Staff Report to the Zoning Administrator

Application Number: **05-0385**

Project Description: Proposal to demolish an existing 5,500 sq. ft. church and day care building, grade approx. 3,000 cu. yds. and construct a 19,726 sq. ft. church to include sanctuary, social hall with kitchen, community meeting rooms, day care center and administrative offices with related parking and site improvements. Project includes an overheight fence in the front yard setback at the day care center.

Location: 2091 17th Avenue, Santa Cruz

EAST ELEVATION
SCALE: 1/8" = 1'-0"

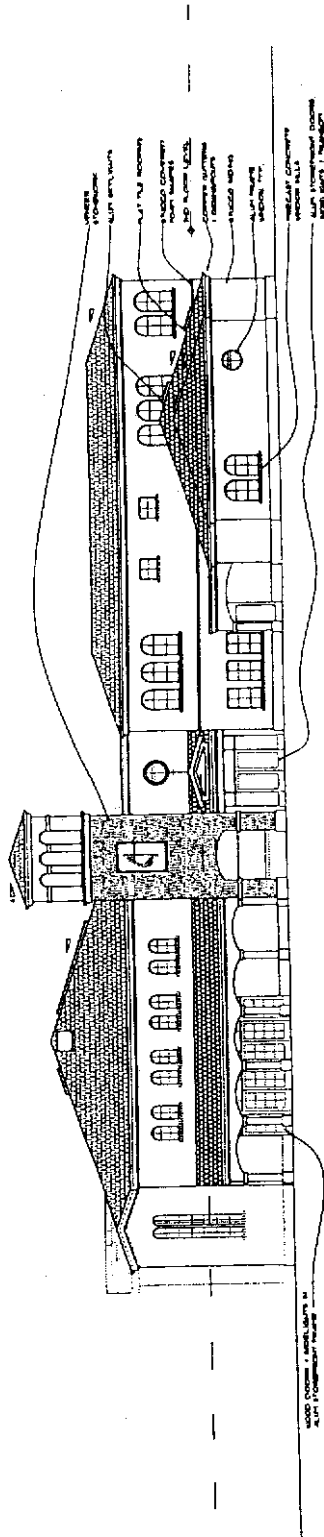
Staff recommends an exception to allow the maximum height of the main roof to be 33'-0" according to the section cited above. Findings for a variance for any height above cannot be justified, because the lot does not have unusual physical characteristics. A condition of approval has been added to revise the design to accommodate the maximum height to be 33 feet.

7. The Roof Plan and Elevations shall show the ~~maximum~~ height to be 33'-0".
8. In order to ensure that impacts from geotechnical hazards are less than significant, prior to the issuance of any building permit, the applicant shall revise the plans to reflect all the recommendations of the geotechnical report.

Existing Conditions & Site Demolition Plan

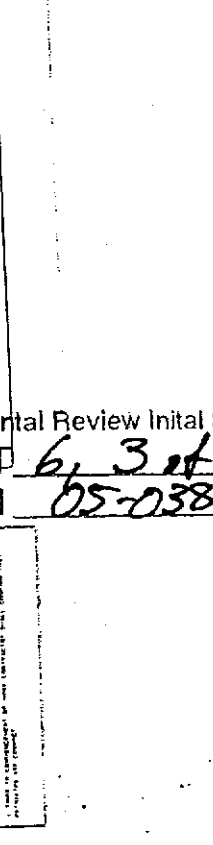
2) Please describe how the existing site drains. Sheet C02 shows existing catch basins on site. where **do** these lead? Do the existing 4" **pvc** pipes shown near the

6) The predevelopment impervious area shown on sheet C02 and in the drainage calculations on sheet C03 are inconsistent.

EAST ELEVATION
 SCALE: 1/8" = 1'-0"

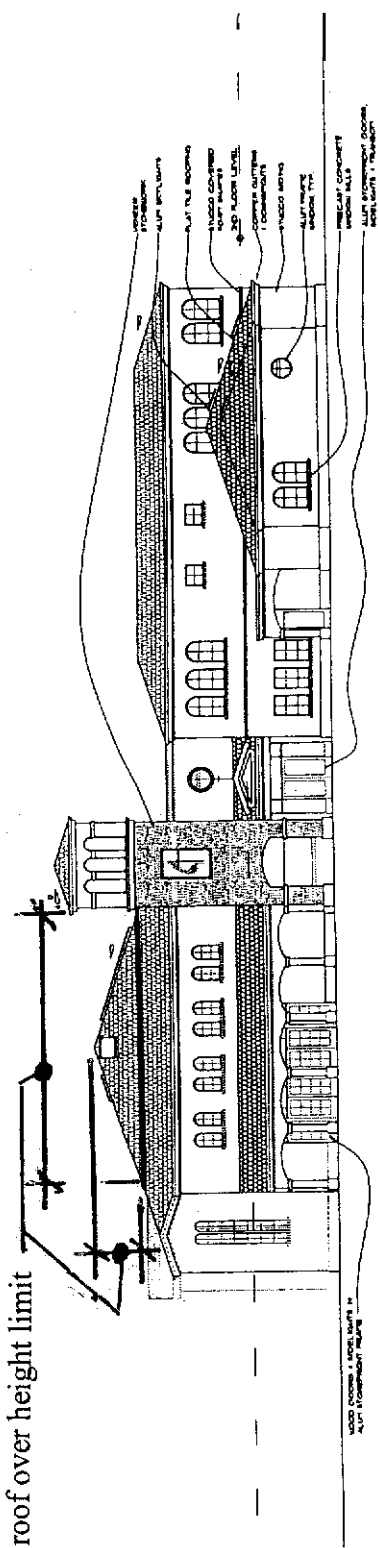
Portion of roof over height limit

WEST ELEVATION
 SCALE: 1/8" = 1'-0"

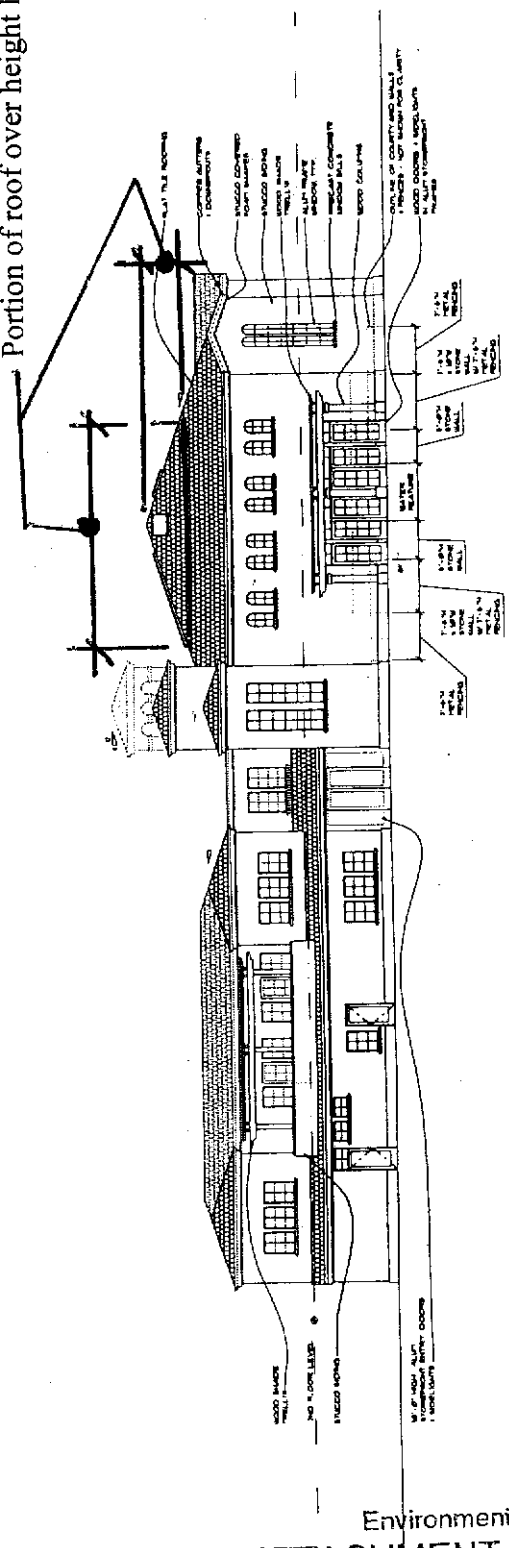
Portion of roof over height limit
